By **CONTACT ENERGY LIMITED**

**STATEMENT OF EVIDENCE OF BRADDYN THOMAS COOMBS (LANDSCAPE,
VISUAL, AND NATURAL CHARACTER EFFECTS) ON BEHALF OF CONTACT
ENERGY LIMITED**

RHYS GIRVAN PEER REVIEW (SDC)

Figure 1: Slopedown / Mokoreta – Pukemimihau ONF candidate assessment sheet and map from the SMRLA study

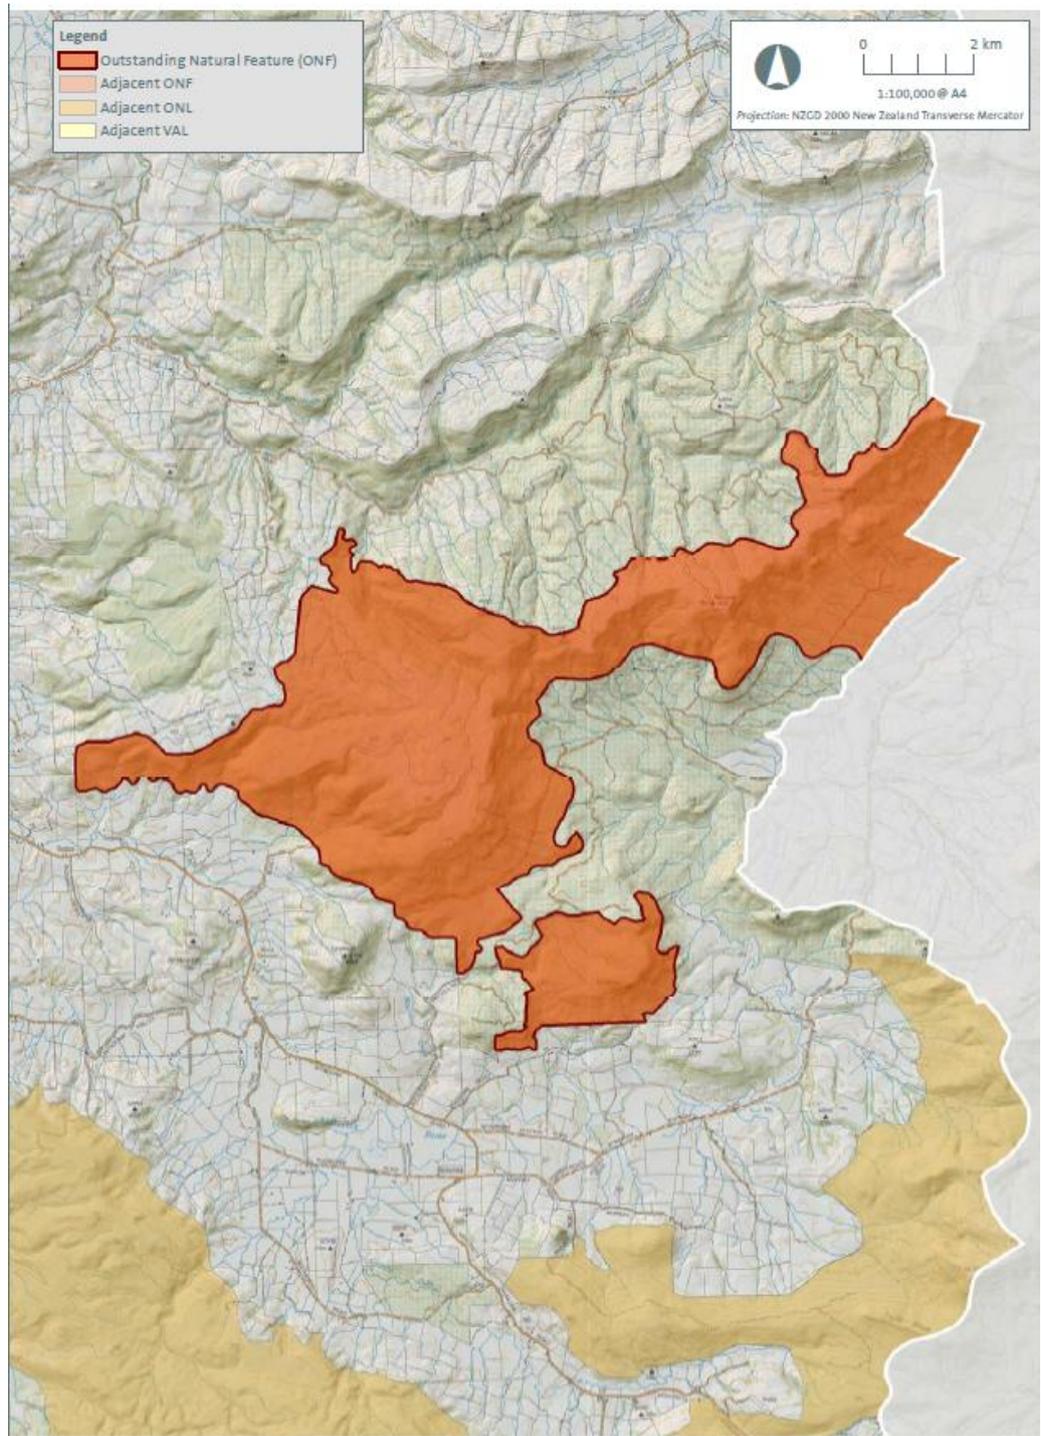
14. As the Panel will be aware from its site visit and the various other maps it has before it (including the site visit maps provided by Contact in response to the Panel's Minute 3), the SMRLA map in **Figure 1** illustrates that the candidate ONF in the SMRLA report includes the scarp face, some of the foot slopes below the scarp, the crest of the ridgeline, parts of the upper dip slope, the southern rātā-kāmahi gully, the Jedburgh Plateau, parts of the pastoral slopes below the plateau and the physically separate landform of Mount Herbert. The mapped area contains varying types and stature of vegetation, including native forest, a mosaic of wetland vegetation and pasture, scrub and grazed pastoral areas. Plantation forests are noted as being excluded from the mapped area. Some areas are within the Catlins Conservation Park and others are part of a working pastoral station. There is, self-evidently, a wide range of landscape attributes across the ONF candidate area as identified in the SMRLA report.

16. The assessment sheet below in **Figure 1** states that under Sensory Attributes there is a 'Highly coherent sequence of native vegetation and sub-alpine tussock which expresses a notable altitude sequence in harmony with the landform'. The Biophysical Attributes on the sheet also refer to "the tops [having] a significant amount of intact red tussock and peatlands".

17. In my opinion the values identified on the ONF candidate sheet are primarily located on the scarp and on other parts of the Conservation Park, and so are outside of the wind farm Project site. In respect of the Jedburgh Plateau in

particular, which appears to be the main location where myself, Mr Bray, and Mr Girvan have different views as to ONF status, there are no areas of "*intact red tussock*"; I have spoken with Mr Goldwater who confirms there is no tussock along the crest or on the Jedburgh Plateau. Nor, I understand from Mr Goldwater and Mr MacGibbon, are there extensive peatlands on the Jedburgh Plateau. While there are a number of bog and fen wetlands, as their assessments describe, I am advised that the bogs at Jedburgh are shallow, rain-fed wetlands with low nutrients and generally high acidity but they are not or have not, to date, been peat-forming other than in a minor way. I also understand that the majority of bog wetlands have been induced through the clearance of vegetation by fire and farming activity over the past century.

Figure 2: Slopdown / Mokoreta – Pukemimihau ONF candidate map from the SMRLA study with landform areas annotated.

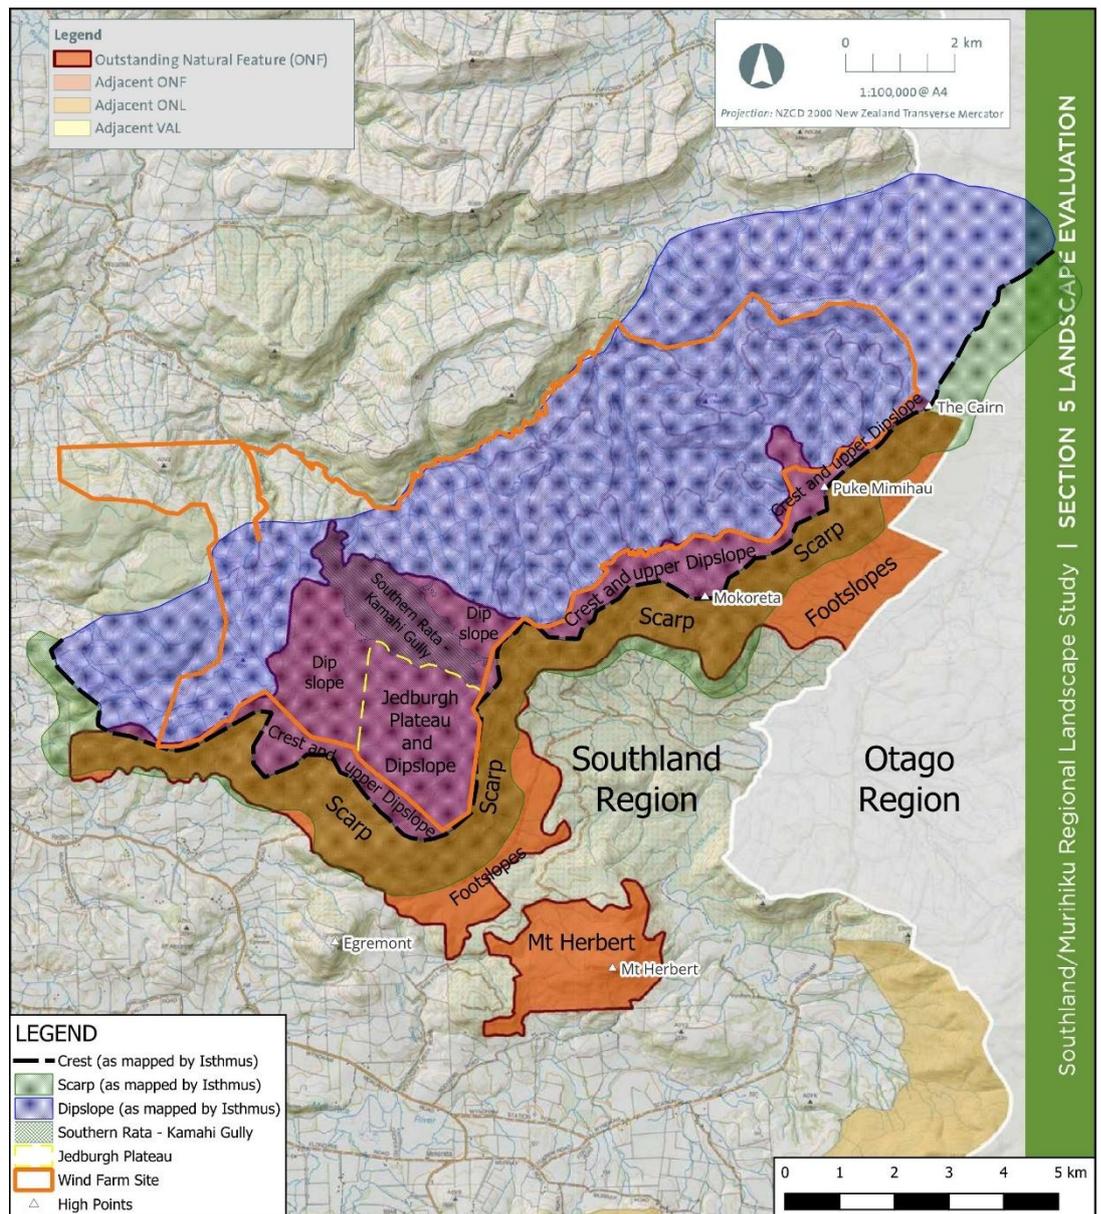
15. **Figure 2** below is the Slopedown / Mokoreta – Pukemimihau ONF candidate map from the SMRLA report, with the landforms annotated to illustrate the variability of the landform topography of the ONF candidate.

roads and turbine foundations generally avoid the more visible bush clad scarp.¹⁴ I would add that the access roads and turbine foundations **completely** physically avoid the bush clad scarp; the scarp, as it is mapped on **Figure 3** on page 42 of my Technical Assessment and in **Figure 2** above, is outside of the Project site. This is also evident on the Project video that was created to illustrate the context of the wind farm layout in the wider landscape.
